Stormwater GEC Plan comments.pdf Markup Summary

[4] G-4 Initial Erosion Control Plan South (4)

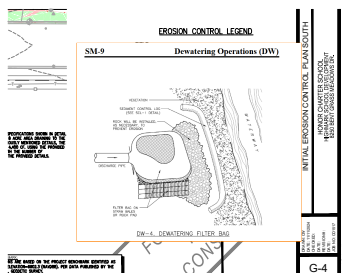
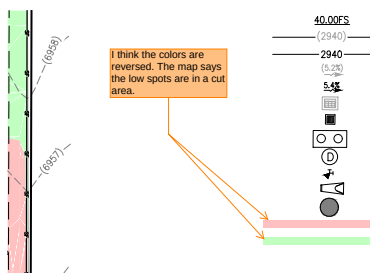
Please provide a detail for the sediment basin and show the proposed outlet pipe on the plans. I know this site is flat and it might be difficult to daylight the traditional outlet pipe, a few alternatives you could consider are the skimmer floating outlet or a pump to a dewatering bag (see screenshots from MHFD details below). For the pump you would have to specify in the SWMP that it would run whenever standing water was present in the basin.

TAIT Response:
A detail for the sediment pond and outlet was provided on sheet G-14. The sediment basin note has been updated to allow for a pump/dewatering process should the site prove to be too flat for a gravity outlet.

TAIT Response:
A detail for the sediment pond and outlet was provided on sheet G-14. The sediment basin note has been updated to allow for a pump/dewatering process should the site prove to be too flat for a gravity outlet.

TAIT Response:
A detail for the sediment pond and outlet was provided on sheet G-14. The sediment basin note has been updated to allow for a pump/dewatering process should the site prove to be too flat for a gravity outlet.

Subject: SW - Textbox with Arrow
Page Label: [4] G-4 Initial Erosion Control Plan South
Author: EPC Stormwater- Zachary

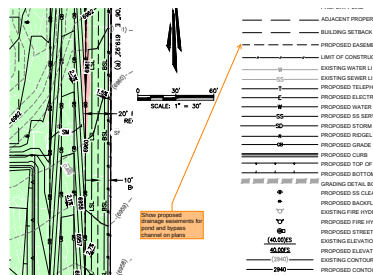
I think the colors are reversed. The map says the low spots are in a cut area.

TAIT Response:
The legend has been updated

[13] G-13 ECP Details 3 (1)

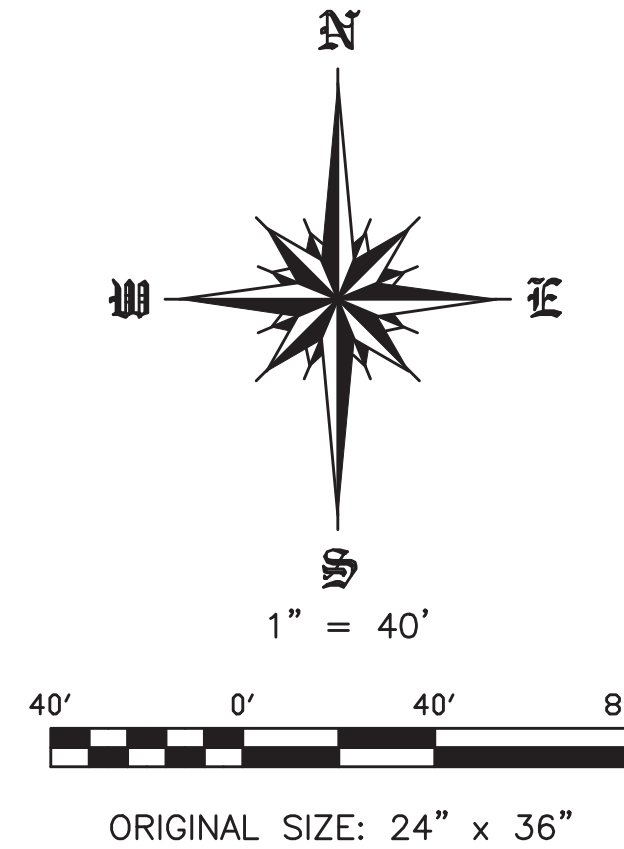
Add a note stating the name of the seed mix and that full seeding details can be found in the landscaping plan

Add a note stating the name of the seed mix and that full seeding details can be found in the landscaping plan

TAIT Response:
Seed mix note has been added

EDUCATIONAL INSTITUTION SUBDIVISION EXEMPTION

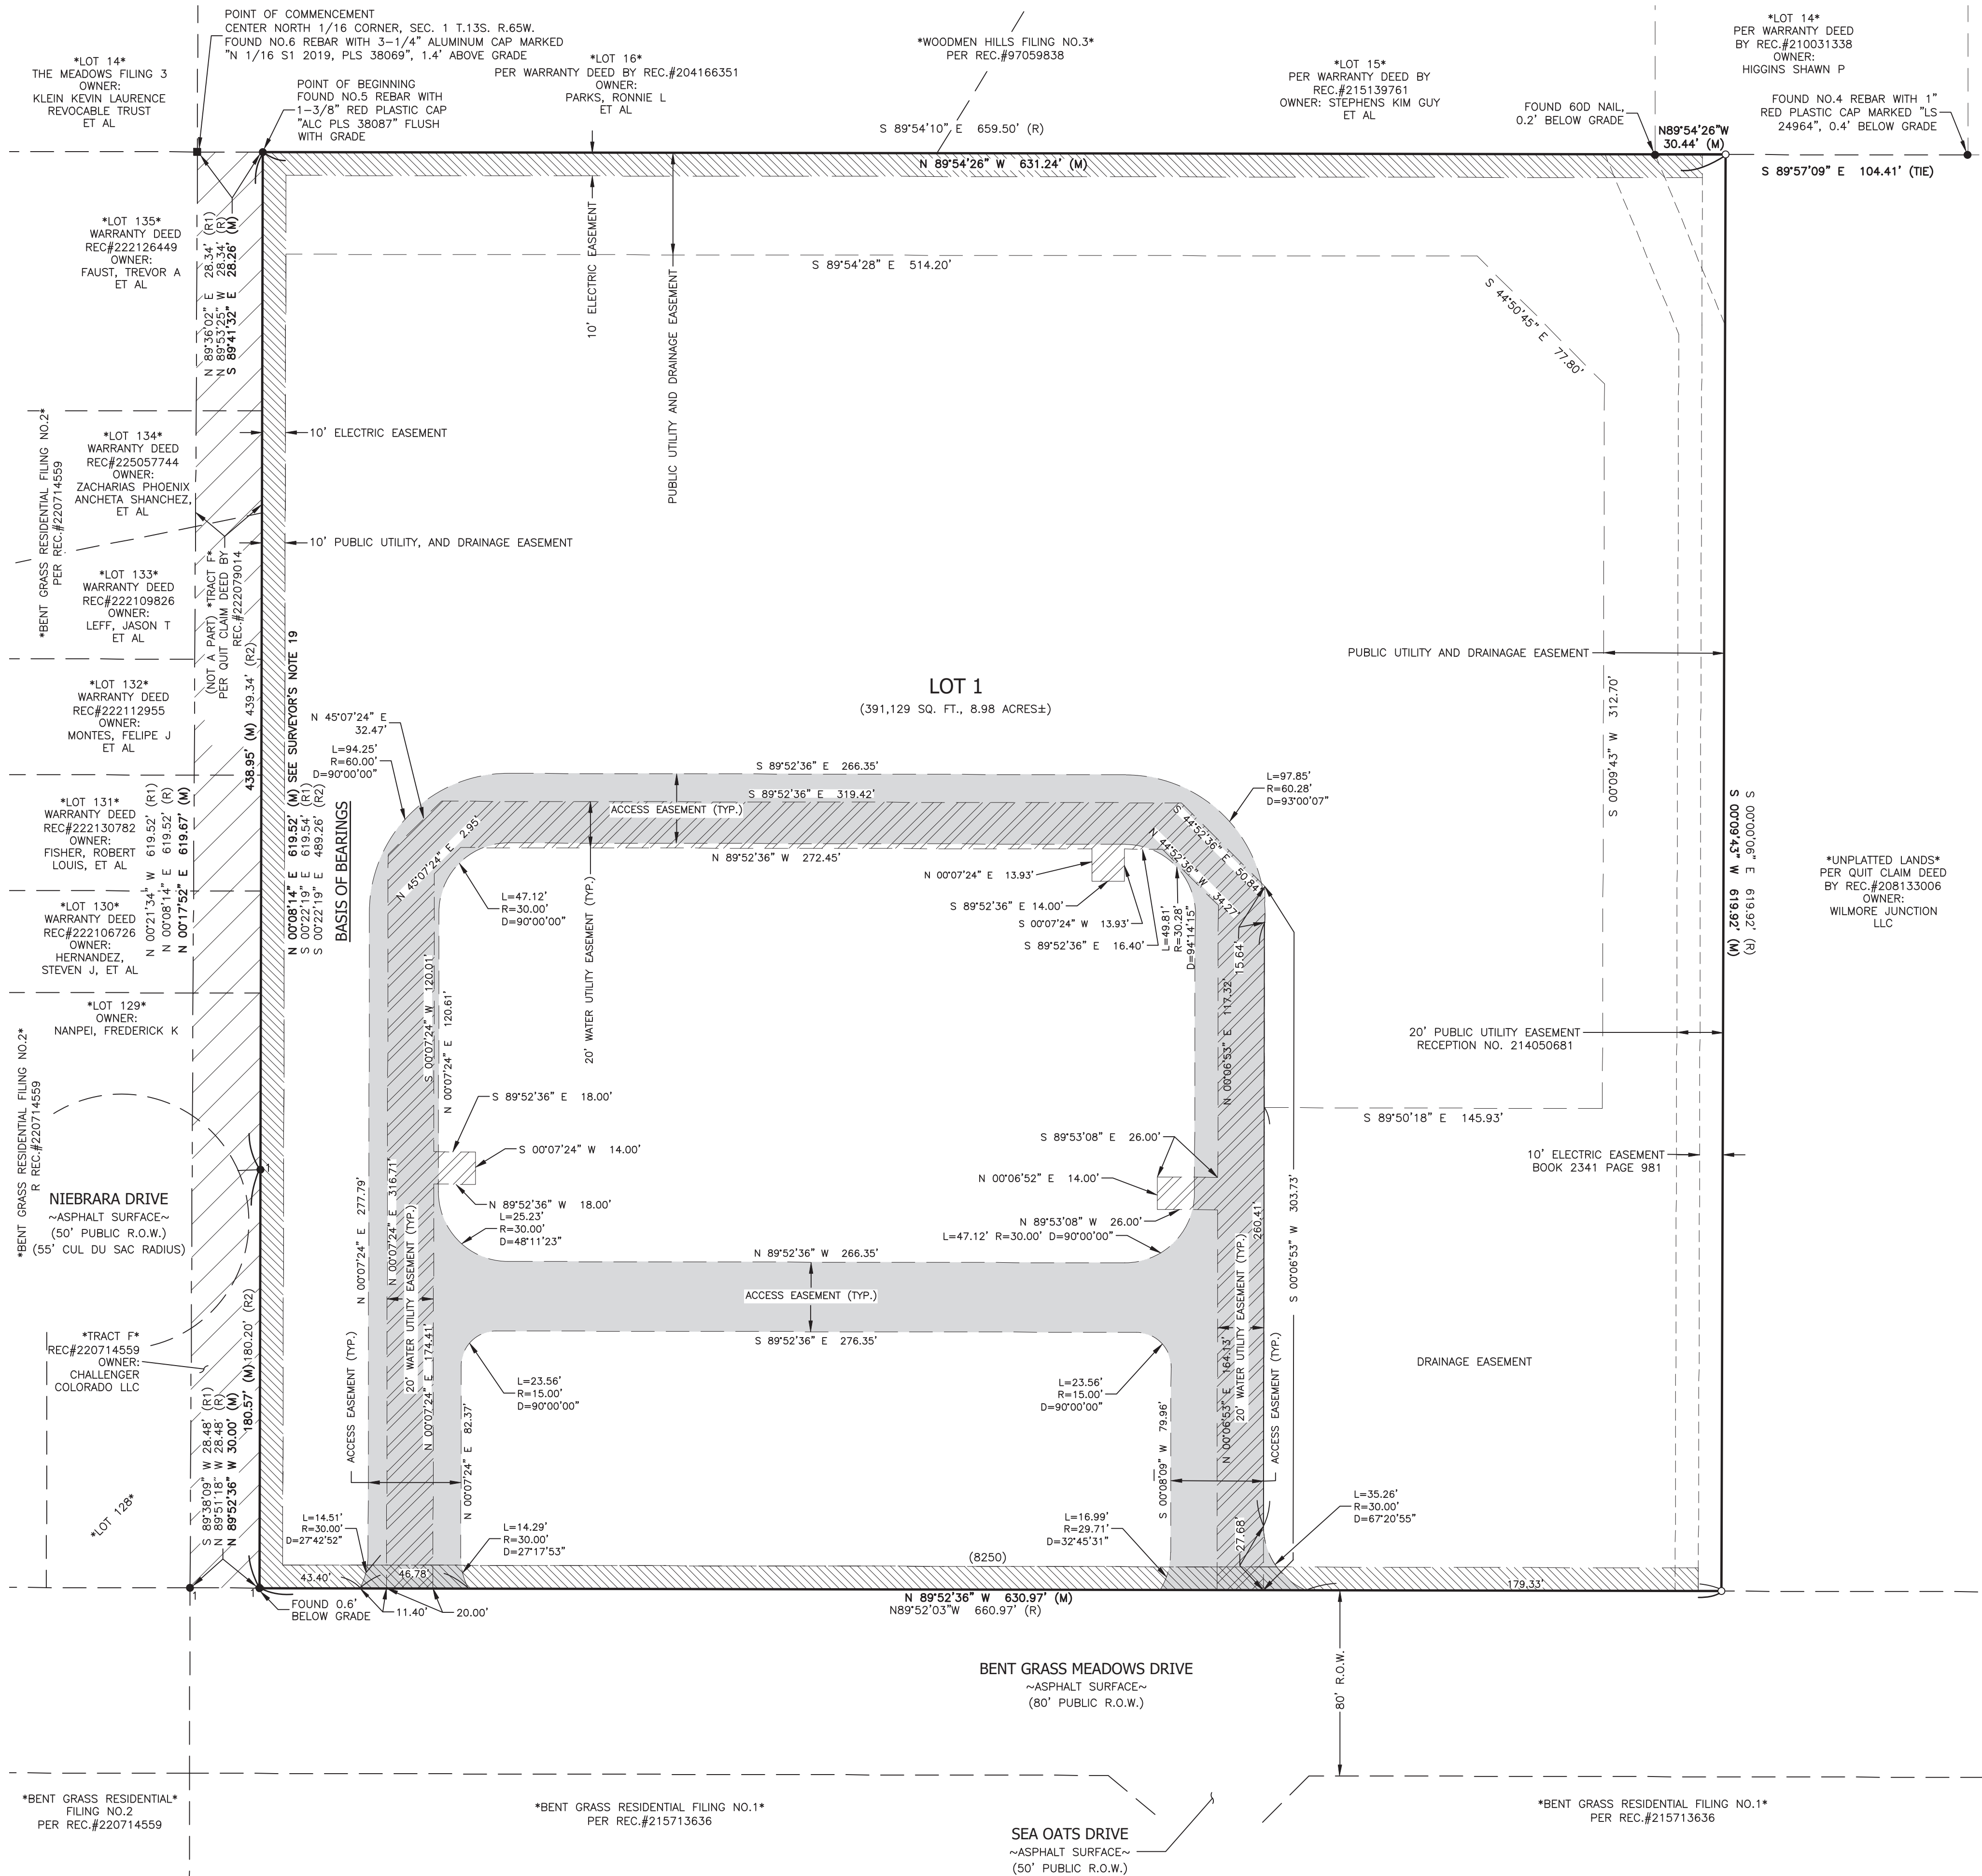
Show proposed drainage easements for pond and bypass channel on plans

TAIT Response:
Proposed drainage easement has been shown on the plans. Callouts have been added for the easement but it underlaying other linework for the fence. Please see attached Page below from Subdivision Exemption Plat for the proposed easement.
